Residential Care Facility

Land adjoining 97 Kesterton Rise North Rothbury

Regulatory Compliance Report

BCA Assessment

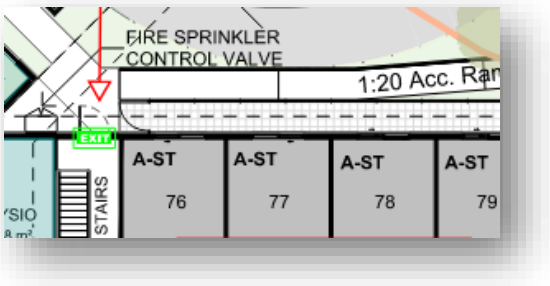
No.	Description	Relevant DTS Clauses	Performance Requirements
	The above items will be addressed in the project fire engineering report.		
3	**Travel via fire-isolated exits** *Ground floor* Path of travel on ground floor necessitates passing within 6m of the external wall in the following areas: ▪ Along the ramp from Northern fire stair

Path of travel on ground floor necessitates passing within 6m of the external wall in the following areas:

Along the ramp from Northern fire stair

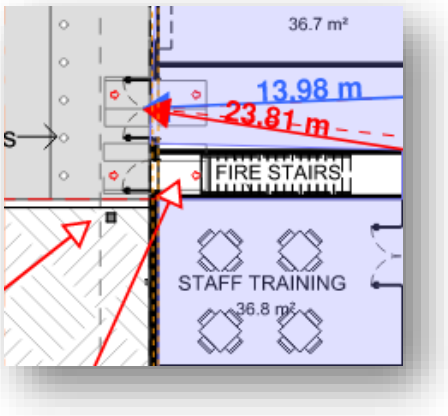
*Basement* Path of travel from the stair necessitates passing within 6m of the external wall and openings.

Basement
Path of travel from the stair necessitates passing within 6m of the external wall and openings.
